Access Compliance Report Public Rights-of-Way (Curb Ramps)

Main Street: **DESSER_LN** Cross Street: **PACIFIC_AVE** Location: **NE**

ADA ID: **RPRK210922120806** Ramp Type: **Type 1 - Perpendicular Diagonal Initial Pass/Fail: Fail** Overall Compliance: **No** Severity Score: **15**

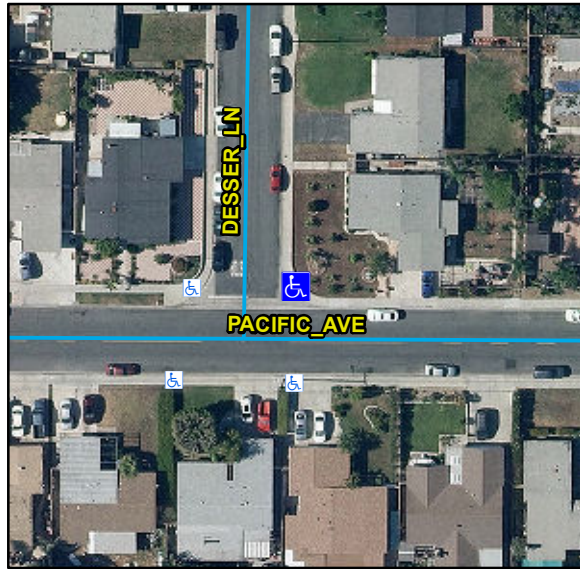
R304.2.2, R302.7.2, STD 1115

Compliance	Description	Data	Compliance	Description	Data
N/A	Ramp Length (in)	55	N/A	Flare Type LT	
Yes	Ramp Width (in)	48			N/A
No	Ramp Run Slope (%)	11.7	N/A	Flare Slope LT (%)	N/A
Yes	Ramp Cross Slope (%)	1.1	N/A	Flare Traversable LT	N/A
N/A	Landing Present	N/A	N/A	Flare Type RT	
N/A	Landing Length (in)	N/A			N/A
N/A	Landing Width (in)	N/A	N/A	Flare Slope RT (%)	N/A
N/A	Landing Run Slope (%)	N/A	N/A	Flare Traversable RT	N/A
N/A	Landing Cross Slope (%)	N/A	N/A	DWS Provided	N/A
N/A	Landing Movement Obstructed?	N/A	N/A	DWS Contrast	N/A
	Landing Movement Type	N/A	N/A	DWS Length (in)	N/A
N/A	Landing Shared	N/A	N/A	DWS Full Width	N/A
N/A	Clear Space	Yes	N/A	DWS Offset Left (in)	N/A
N/A	Clear Space To Crosswalk (in)	N/A	N/A	DWS Offset Right (in)	N/A
N/A	Marked Crosswalk 1	No	N/A	Marked Crosswalk 2	No
	Crossing 1 Direction	W		Crossing 2 Direction	S
	Marked Crosswalk 1 Width (in)	N/A		Marked Crosswalk 2 Width (in)	N/A

N/A	Ramp Inside Crosswalk 1	N/A	Yes	Ramp Inside Crosswalk 2	N/A
	Crossing 1 Slope (%)	1.1		Crossing 2 Slope (%)	4.3
	Crossing 1 Cross Slope (%)	1.7		Crossing 2 Cross Slope (%)	0.2
N/A	Gutter Ponding	N/A	No	Curb Slope	5.9
No	Gutter Lip Height (in)	0.5		Road Run Slope (%)	0.3
N/A	Gutter Run Slope (%)	N/A		Road Cross Slope (%)	1.3
N/A	Gutter Cross Slope (%)	N/A			
Yes	Overall Surface Condition: Acceptable		Yes	Perp Joint Present	Yes
	Cross Gutter Present?	Yes		Spandrel Present?	Yes
	Replace Cross Gutter?	No		Replace Spandrel?	No

Remove & Replace Curb Ramp With Two New Directional Ramps or Equivalent.
